Sub: Inspection Report of Bajoli Holj HEP.

180 MW BAJOLI HOLI HYDRO ELECTRIC PROJECT

**PROPOSAL FOR SHIFTING OF BANK FROM RIGHT TO LEFT
SITE INSPECTION REPORT OF DIRECTOR (CIVIL)**

(Date of Visit to Project Site: 18th July 2012)

Client	GMR BAJAJI HYDRO POWER PVT. LTD. GMR
Project	BAJAJI HOLI HYDRO ELECTRIC PROJECT (3 x 60 MW)
Drawn	PIT TYPE POWER HOUSE CROSS SECTION (AS PER HFSEB PROJECT REPORT)
Checked	GMR GMR CONSULTING SERVICES PVT. LTD.
Scale	1:200
Date

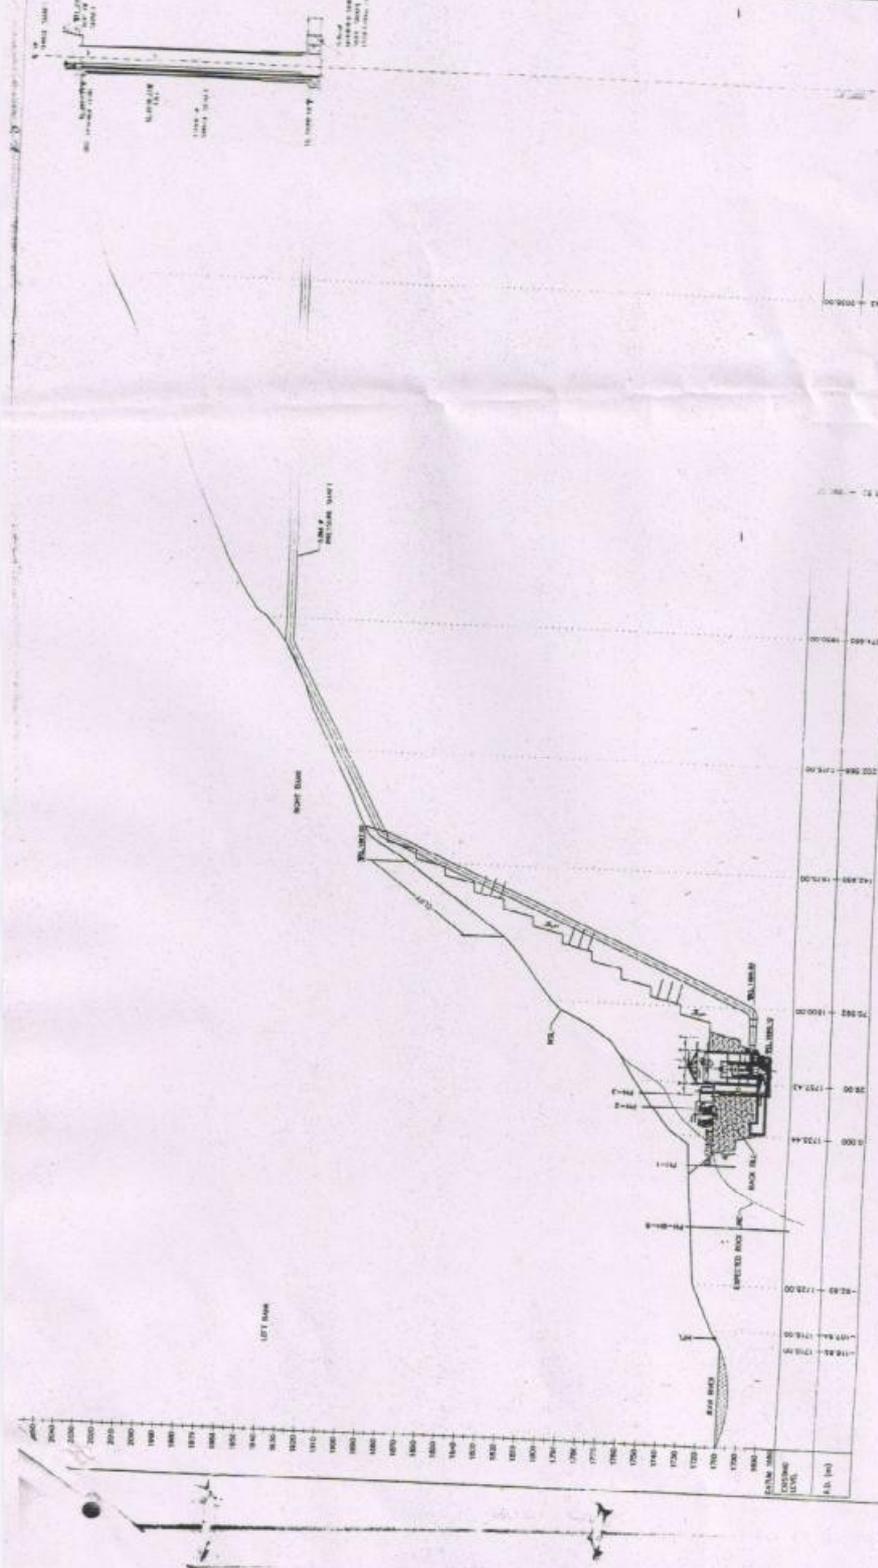
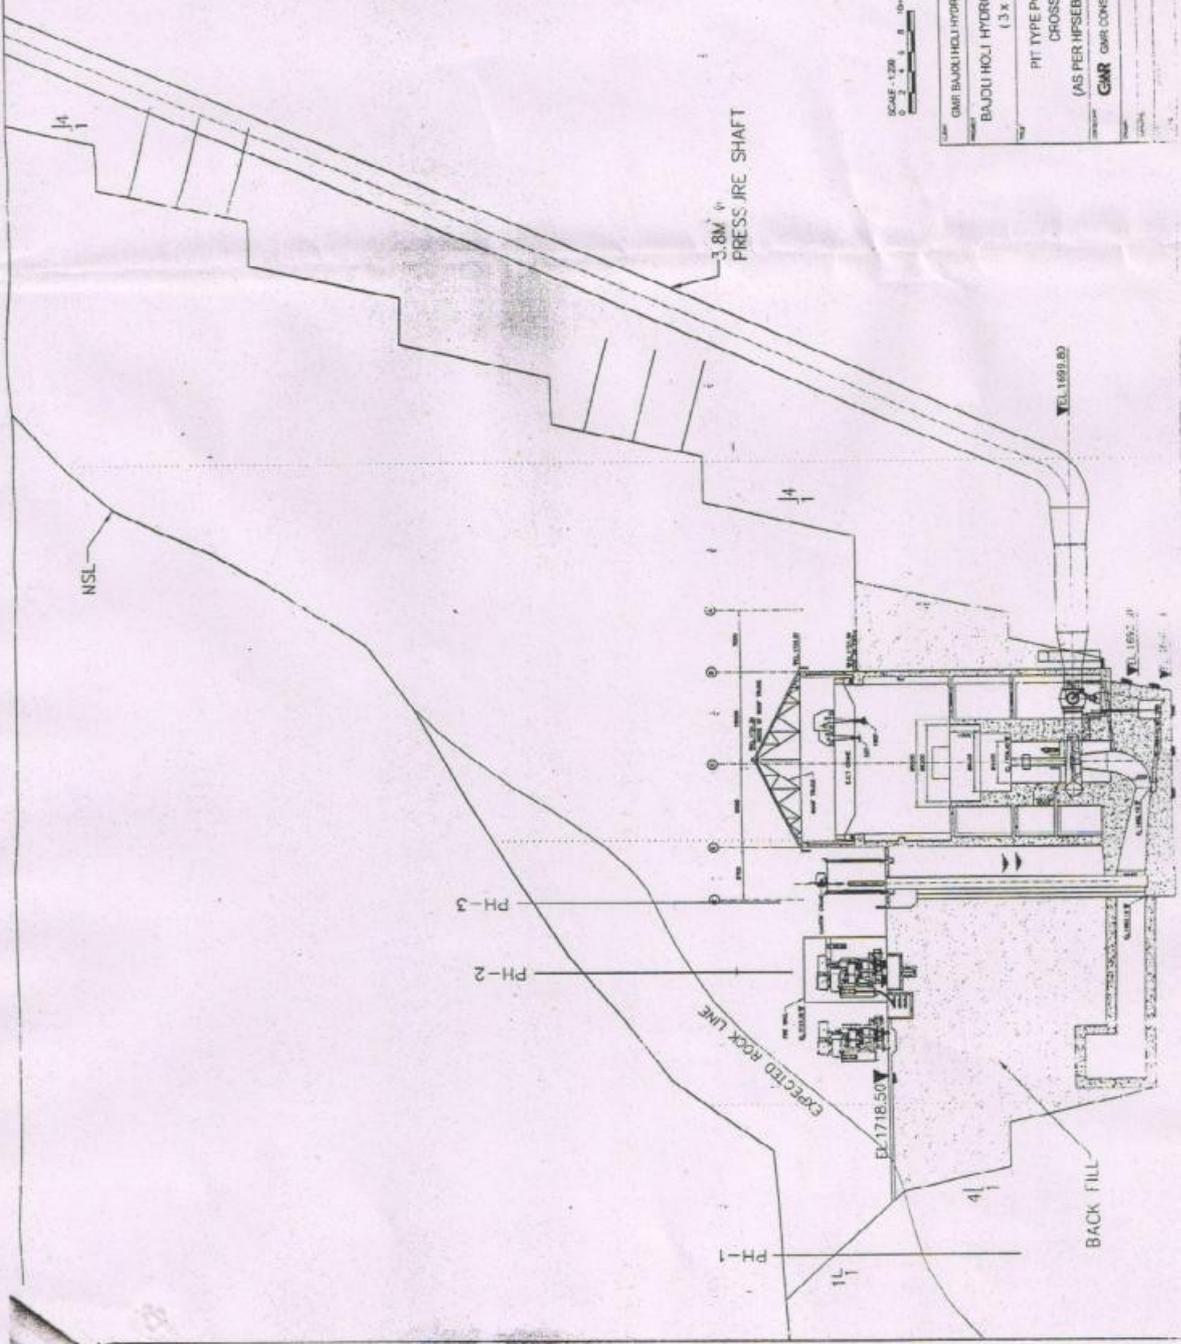
It may also be mentioned that the pit powerhouse proposed by HPSEB Ltd as depicted in GMR drawing enclosed with its Assessment Note deviates from the drawing made during Field Season by GSI Geologist. In the GMR drawing the powerhouse has been shown to be set deeper compared to GSI drawing. The GMR drawing although purporting to represent HPSEB layout actually depicts the powerhouse shifted towards the hill. The shift is responsible for the higher back cut predicted by GMR.

There is no need to shift the powerhouse back as proposed by consultants of GMR. Geological Survey of India has approved the site on the basis of field data. There should be no doubt about its soundness. GSI has vast experience of Indian geology. It has finalized the layouts of
